**Remedial Investigation Addendum for  
Waste Area Grouping 22, Burial Grounds,  
Solid Waste Management Units 2 and 3,  
at the Paducah Gaseous Diffusion Plant,  
Paducah, Kentucky**

SEPTEMBER 1994  
REVISION 2

# **Response to Comments**

**RESPONSE TO KY DEP AND U.S. EPA COMMENTS**  
**Draft Remedial Investigation Addendum**  
**Waste Area Grouping 22, Burial Grounds**  
**Paducah Gaseous Diffusion Plant, Paducah Kentucky**

**Figure 2-3**  
**PHYSICAL FEATURES OF WMU 2: C-749 URANIUM BURIAL GROUND AND WMU 3: C-404 LOW-LEVEL RADIOACTIVE WASTE BURIAL GROUND**  
 PADUCAH GASEOUS DIFFUSION PLANT  
 PADUCAH, KY.

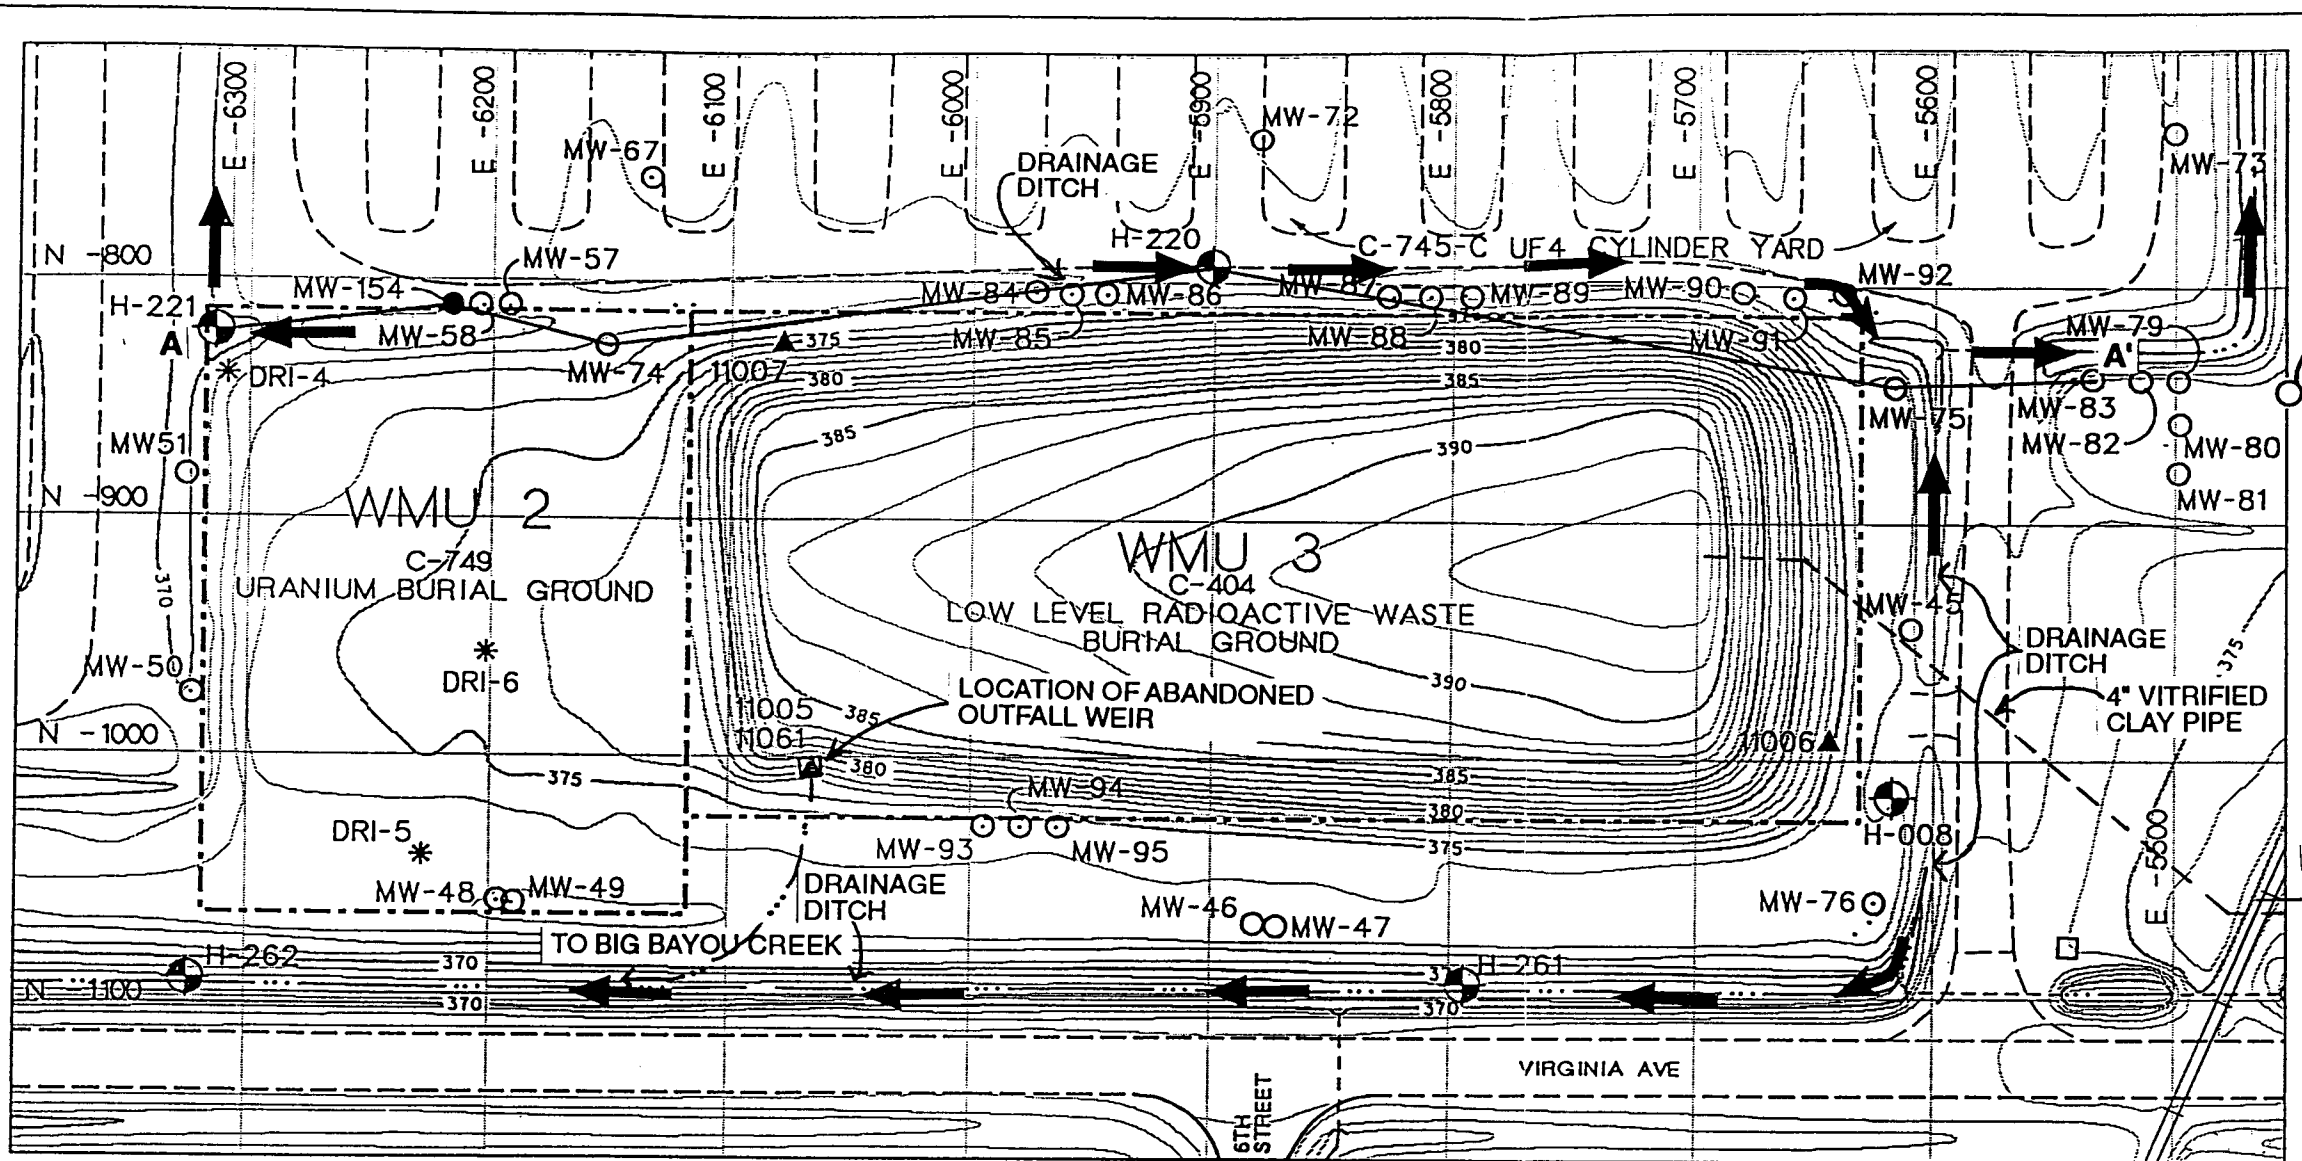
7.	Section 2.2.2.2; Page 2-15; Paragraph 6	Referenced well MW-78 is not located on Figure 2-3. The figure should be prepared so that all referenced wells, borings and sampling points are shown.	Agree. Figure will be revised to show well location.

8.	Section 2.2.2.2; Page 2-16; Paragraph 2	The location of surface water and sediment sampling points should be provided.	Sampling locations for the WMU 3 underdrain and leachate samples are shown on Figure 2-3.

9.	Section 2.3.1; Page 2-16; Figure 2-3	The figure does not clearly show the drainage patterns and ditches referenced in the text. The figure should clearly show all referenced features including outfall 015.	Agree. Figures 2-1 and 2-3 were revised and ditches were identified to show surface drainage direction

**Figure 2-5**  
**CONCEPTUAL SITE MODEL**  
**WMUs 2 AND 3**  
**PADUCAH GASEOUS DIFFUSION PLANT**  
 PADUCAH, KY.

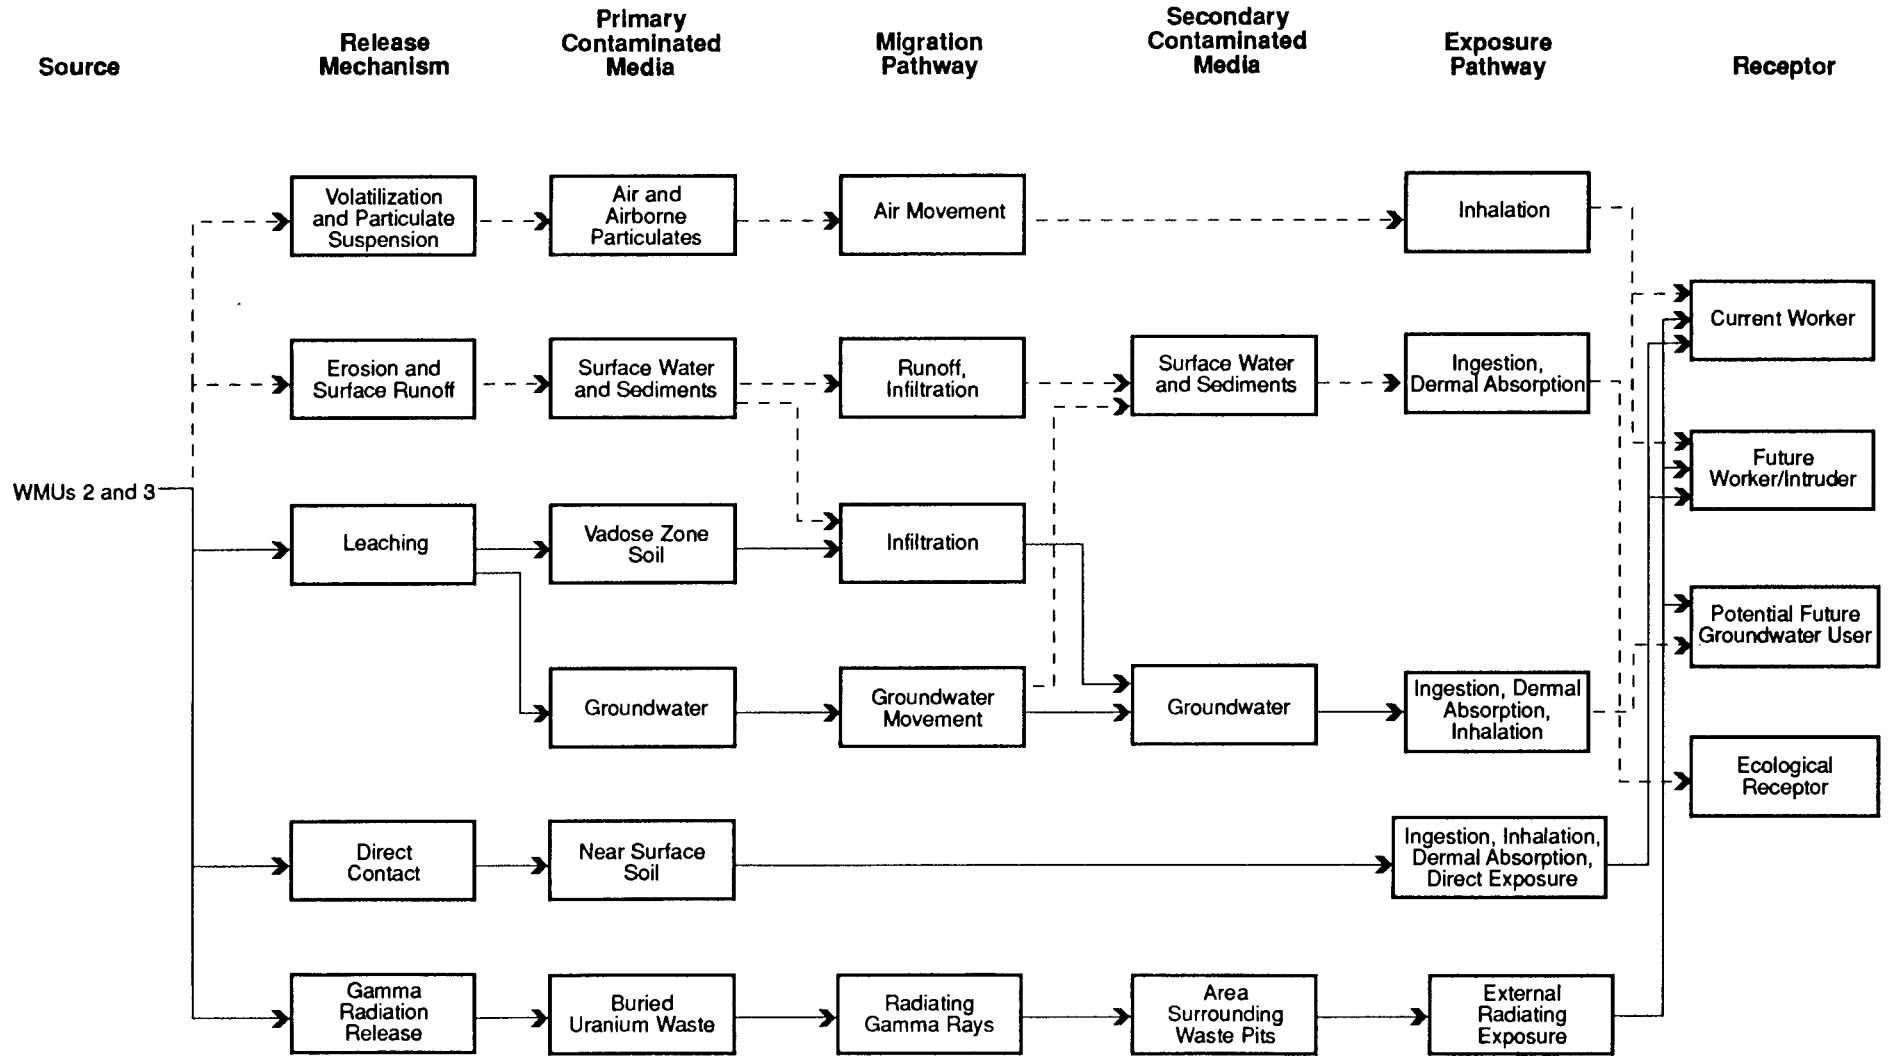
7.	Figure 2-5 Page 2-13	Inhalation of volatiles and dermal contact is left out of the exposure pathway for groundwater.	Agree. This figure will be corrected as requested.

**Figure 2-6**  
**STRATIGRAPHIC CROSS-SECTION**  
**OF WMUs 2 AND 3**  
**PADUCAH GASEOUS DIFFUSION PLANT**  
**PADUCAH, KY.**

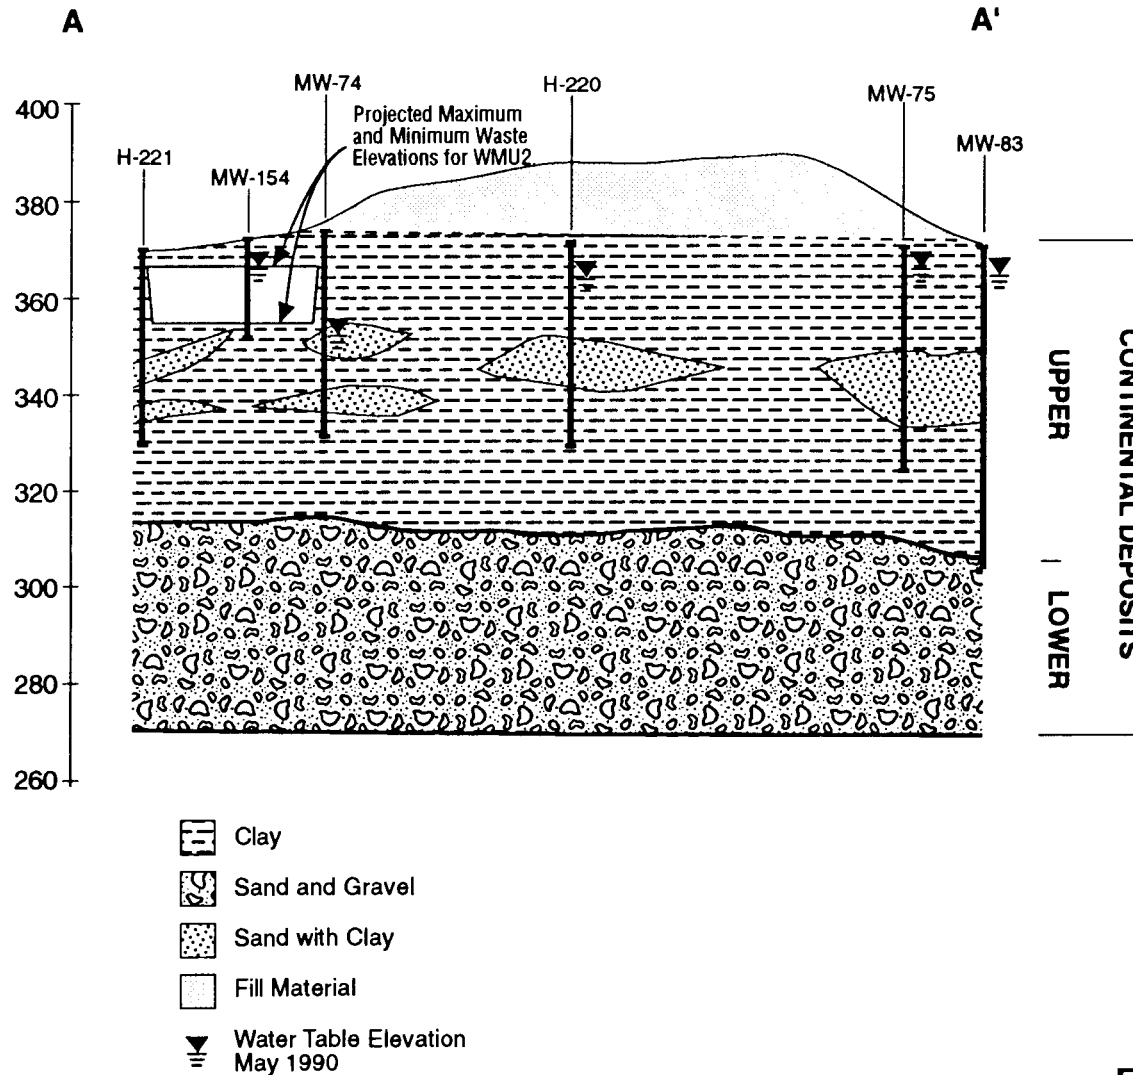
Comment Number	Section/ Page	Comment	Response
12.	Figure 2-6 Page 2-19	This figure should indicate the limits of the WMUs and the average water table height relative to the wastes. Furthermore, why are different wells used for the cross-section in Figure 2-6 than are presented in Figure 2-7, for water-table information? The RI must definitively describe the relationship of the source-material and the phreatic surface, and any temporal variations in this contact.	Agree. Will modify Figure 2-6 to use a more standard plane of points. Refer to KDEP Comment 14, 15, and 16, Response. Different wells are used in Figures 2-5 and 2-7 because Figure 2-6 is not intended to present stratigraphy and Figure 2-7 presents water level fluctuations.

14.	Section 2.3.3; Page 2-19; Figure 2-6	The cross section does not correlate with the boring logs referenced. Also, no cross section line is provided on any of the figures provided in the Addendum. Make the appropriate corrections or additions.	Agree. Will modify Figure 2-6.

15.	Section 2.3.3; Page 2-19; Figure 2-6	The utility of constructing a two-dimensional cross section from the pattern of points is not clear. A fence diagram would seem more appropriate. If a cross section is used, a more standard plane of points should be used.	Will revise to use a more standard plane of points.

Comment Number	Section/ Page	Comment	Response
16.	Section 2.1.1; Page 2-1; paragraph 2	<p>The limits to fill material do not seem appropriate given the following statement:</p> <p style="padding-left: 40px;">Section 2.1.1, Page 2-1, Paragraph 2, which indicates that WMU 2 "consisted of a series of pits excavated to a depth of 7 to 17 feet."</p> <p style="padding-left: 40px;">Considering an approximate surface elevation of 370 feet above mean sea level (ASL) as derived from Figure 2-3, this would indicate a bottom of waste boundary of between 363 to 352 feet ASL.</p> <p>The current limits of the bottom of fill as presented on Figure 2-6 appears to indicate an elevation of 375 feet ASL. The figure should be amended to reflect actual or strongly suspected conditions. This matter is extremely important given its relationship to the likelihood that buried waste is apparently in direct contact with the water table.</p>	<p>Agree. Projected maximum and minimum waste elevations were added to Figure 2-6.</p>

**Figure 2-8**  
**SAMPLING RESULTS AT WMU 2: C-749 URANIUM BURIAL GROUND AND WMU 3: C-404 LOW-LEVEL RADIOACTIVE WASTE BURIAL GROUND**  
PADUCAH GASEOUS DIFFUSION PLANT  
PADUCAH, KY.

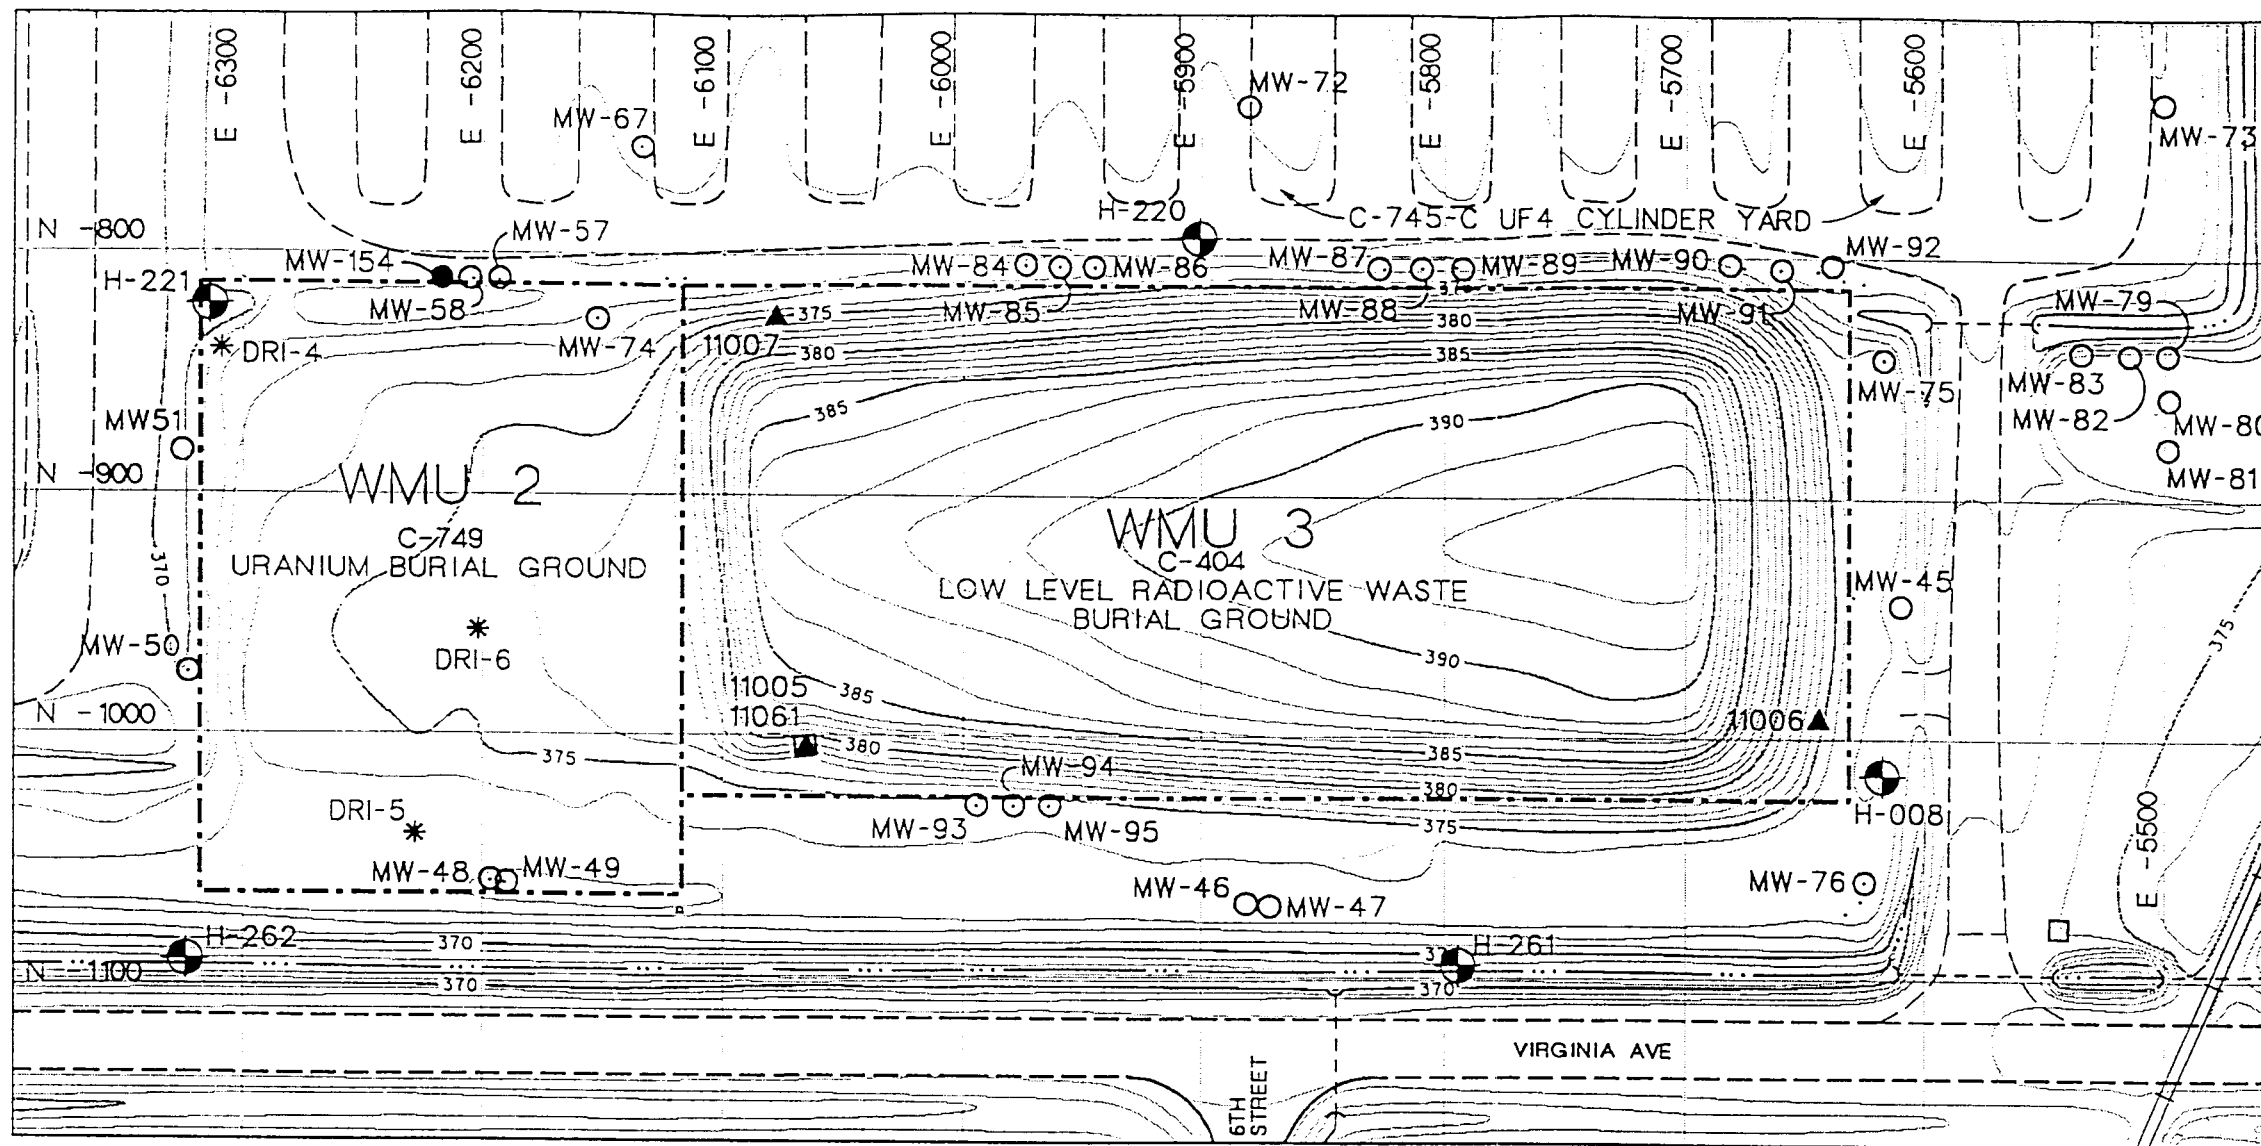
Comment Number	Section/ Page	Comment	Response
20.	Figure 2-8 Page 2-32	Units for radionuclide contamination in soil, and the data reported in brackets are not defined.	Agree. Table and footnotes will be revised.

Comment Number	Section/ Page	Comment	Response
28.	Section 2.4.2; Page 2-32; Figure 2-8	What are the groundwater units on the table within the figure? DMNA and PCP are not defined on table 2-5 or on the figure. Regarding soil results from H008, 0.9 of what? What do the brackets indicate on the tables? The table should indicate that only select soil results (0 to 6 feet) are presented. Make the necessary additions or corrections.	Agree. The table will be corrected/clarified.

30.	Section 2.4.2; Page 2-34; Paragraph 2	Where was the location of the sample collected from the drainage northwest of SWMU 3?	Location is shown on Figure 2-8.
